Application by
Fingal County Council
for Waste Licence Application W0231-01
for Fingal Landfill, Co. Dublin

***Replies to Request
for further information in accordance with
Article 14(2)(b)(ii) of the Waste
Management Regulations***

January 2007

Article 14 Information

<p>Project Fingal Landfill Project</p> <p>Title Groundwater Vulnerability & Clay Thickness</p>	<p>Appendix 2</p>		<p>Issue Details</p>

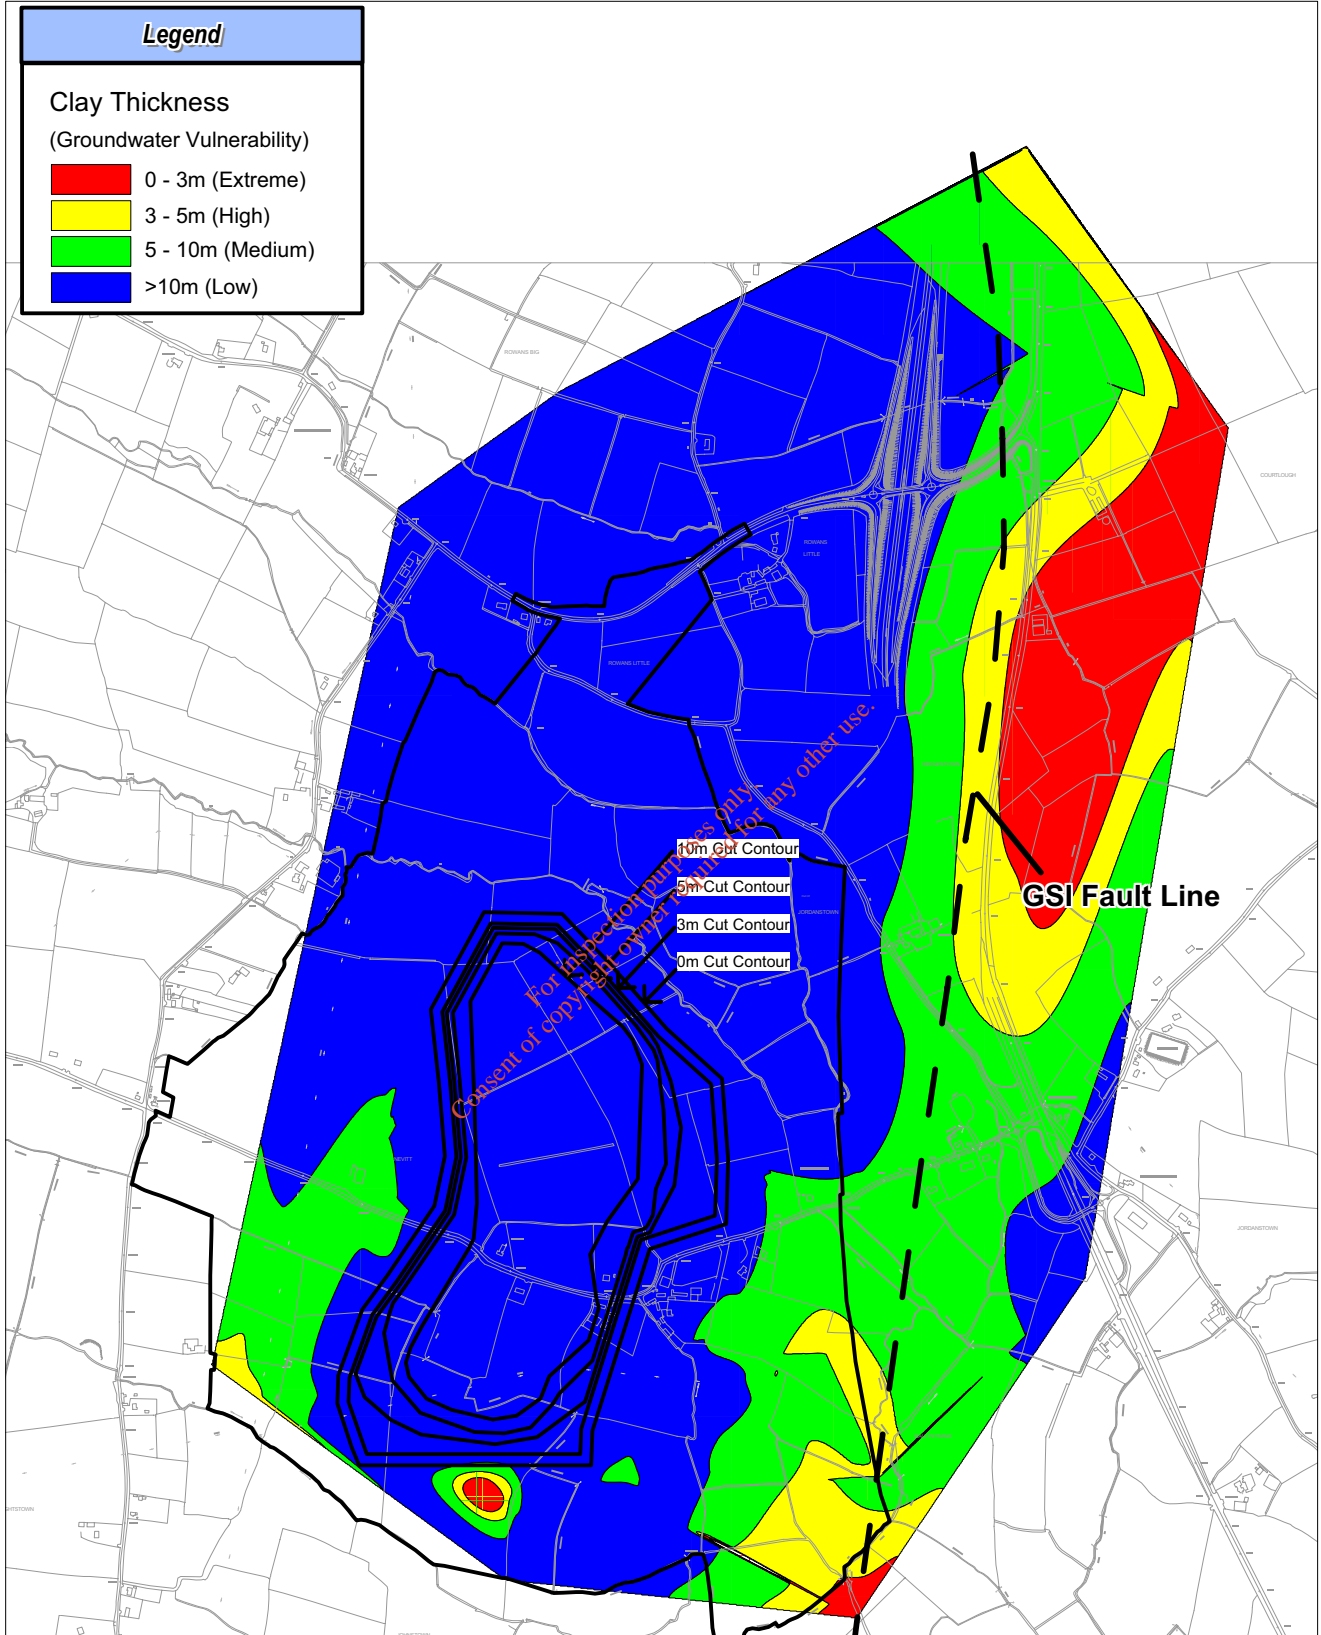
Develop a vulnerability map for the study area based on site investigations carried out to date.

A vulnerability map has been provided, refer to **Appendix 2** 'Proposed Fingal Landfill Groundwater Vulnerability Map'. This map is based on the thickness of subsoil derived from borehole logs for the site. The vulnerability rating for the landfill footprint is **LOW**. Where sand and gravel is present beneath the landfill footprint, there is a minimum of 10m of low permeability clay above it so the vulnerability rating remains **LOW**.

Surface Observations (July 2006)

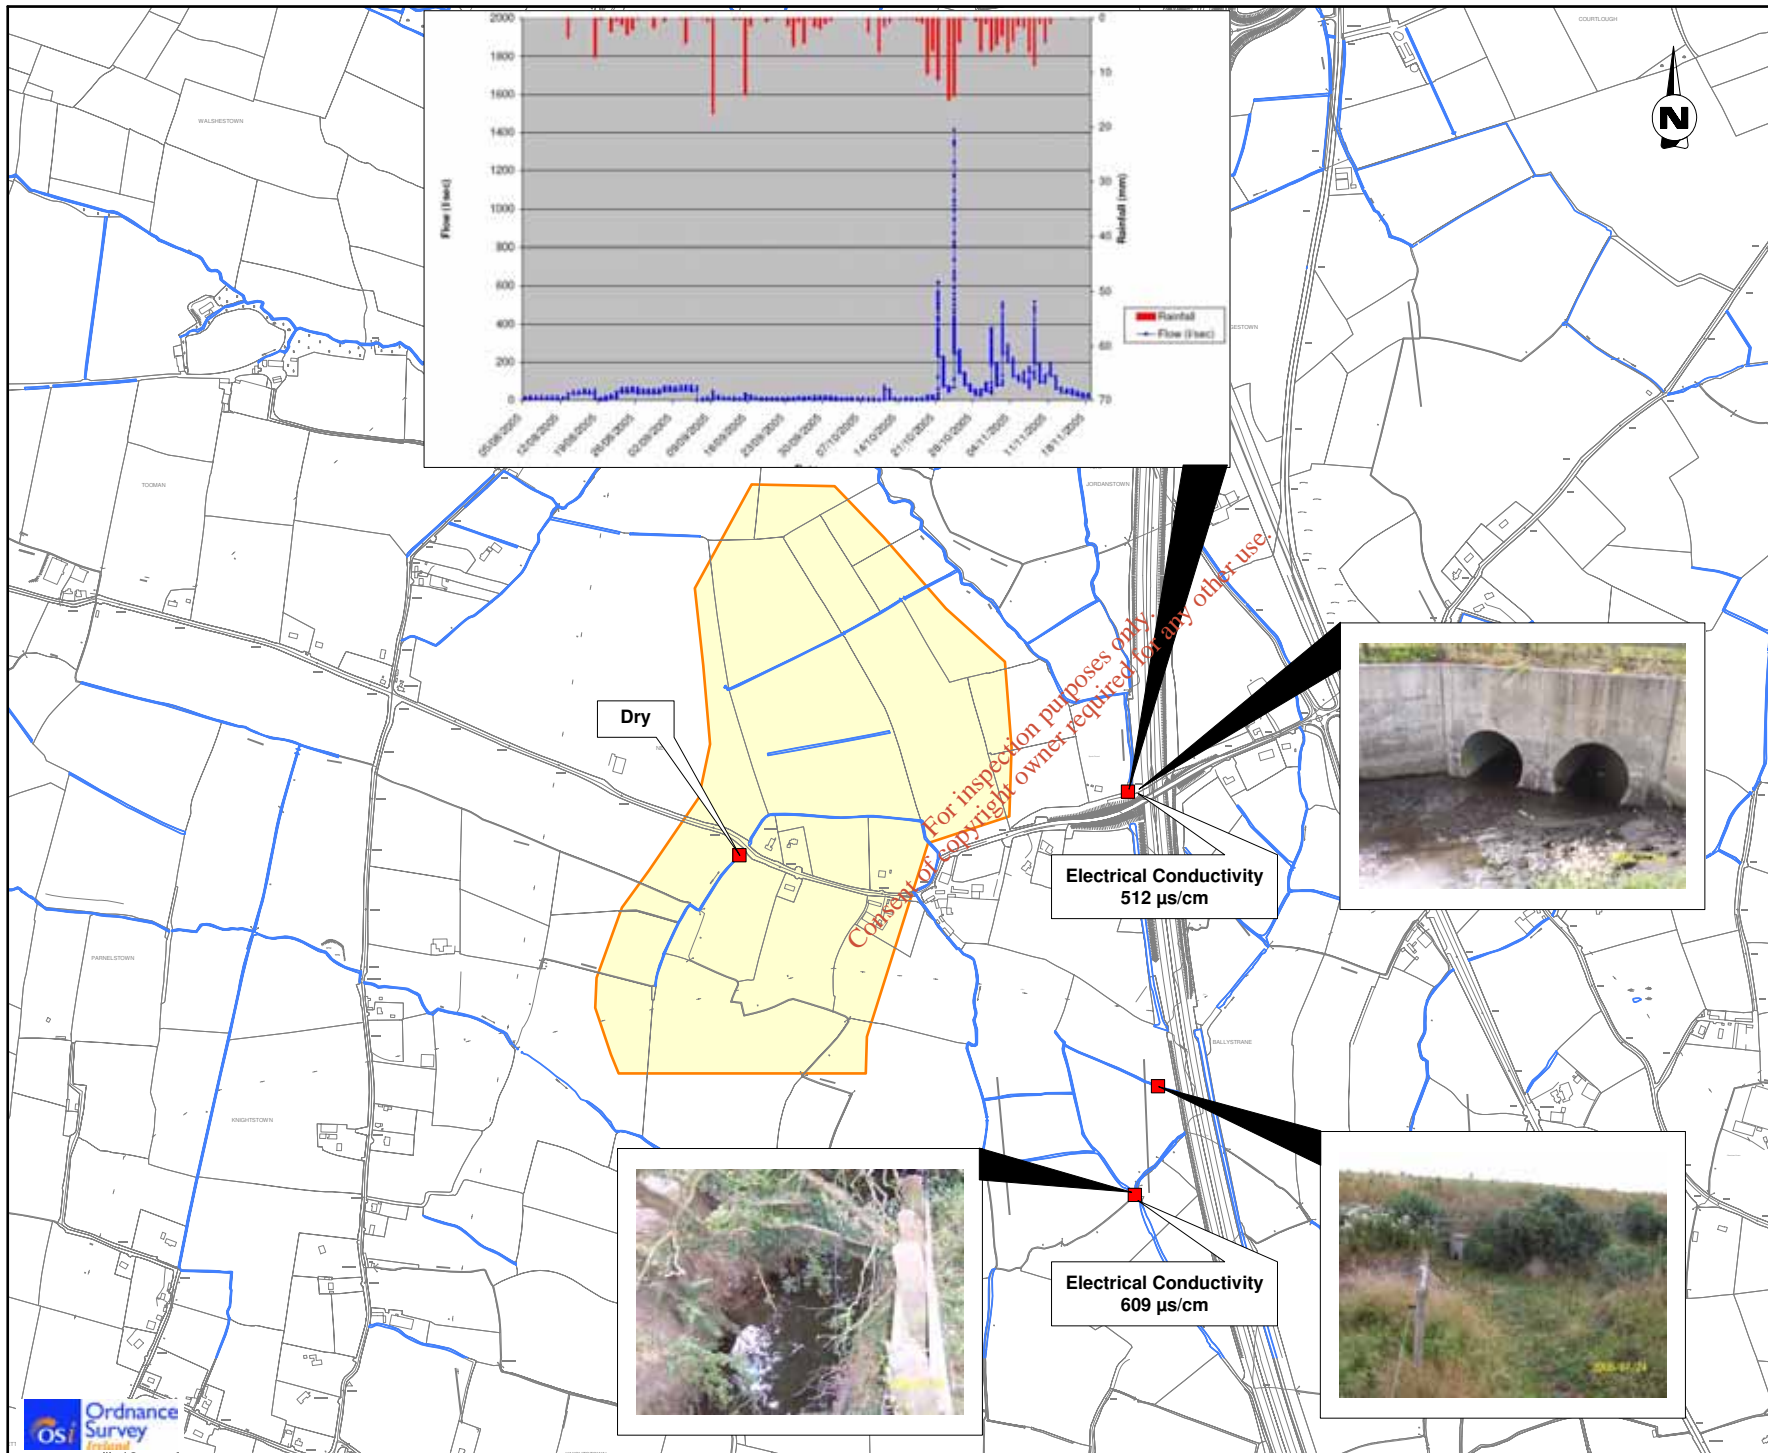
The report completed by Mott McDonald (dated 7th September 2006) submitted on behalf of Nevitt Lusk Action Group queries the cause for the change in hydraulic gradient from the west of the site to the east of the site as demonstrated in the groundwater contour maps in Appendix A5 of Volume 5 Attachment H of the EIS and also in the groundwater contour plots included in the Mott McDonald report. It is suggested that this may be related to the groundwater discharging into a stream on the site, indicating that the clay overburden is not a barrier to groundwater flow. Please comment on the potential reasons for the change in hydraulic gradient and on the likely cause of the change based on information gathered as part of the study investigation.

The change in hydraulic gradient from the west to the east of the site is not considered to be caused by groundwater seepage to surface water in this area. Dry flow observations made in July 2006 (refer to **Appendix 3**) support this, as the stream draining this part of the site was dry.

Title:
GEOLOGICAL CROSS SECTIONS A-A' & B-B'

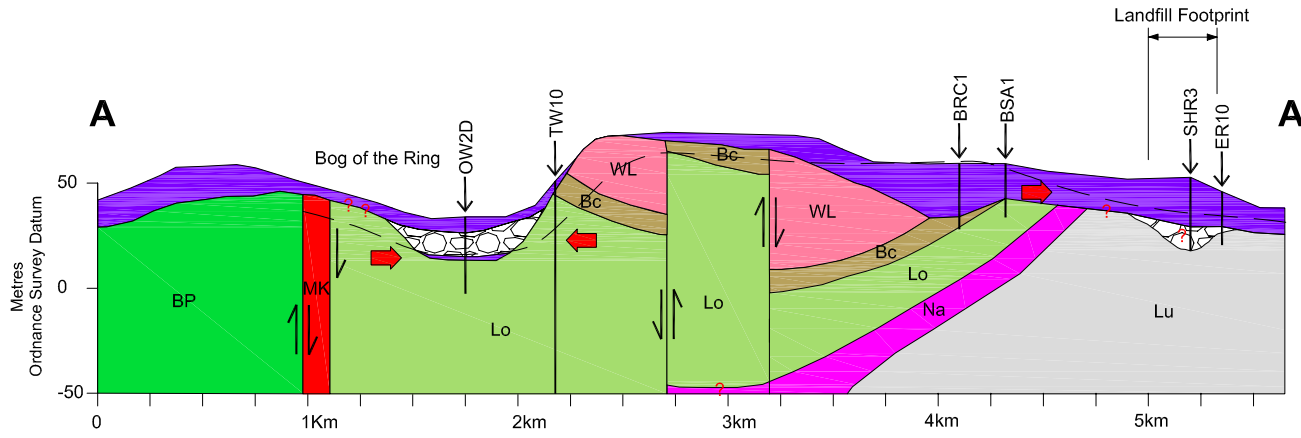
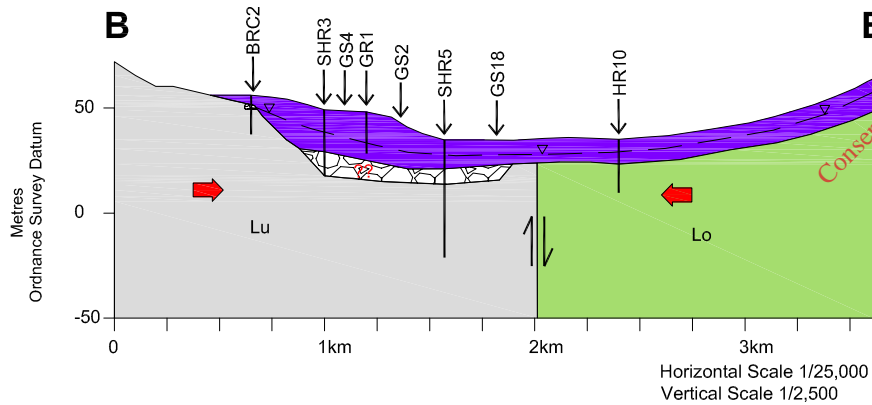
Reassess the accuracy of the information provided in Geological Cross Section A-A” and B – B’ presented in Appendix A1 of Technical Appendix H, taking into account queries on these cross sections submitted by K. Cullen in his submission to the EPA dated 12/09/06.

Geological Cross Section A-A’ and B-B’ presented in Appendix A1 of Technical Appendix H has been amended and is submitted now in **Appendix 4**. Explanations for amendments are outlined below:

1. The log for SHR3 was used as opposed to SHR3a in the amended drawing as SHR3 was closer to the line of the section and did potentially encounter gravel in the logs (20m to completion of borehole at 31.5). It must be stressed that SHR3 was drilled by open hole methods and that recovered material is difficult to classify (i.e. it could be weathered rock or gravel). This borehole was included as it is possible that the gravel exists but because there isn’t 100% certainly that it is gravel, a question mark has been added;
2. The vertical scale and folded beds means that formations can appear too thin or thick based on the dip of the formation. The vertical exaggeration of the Loughshinny Formation has been corrected;
3. The extent of the landfill footprint was revised to include that area that intersected the landfill only.
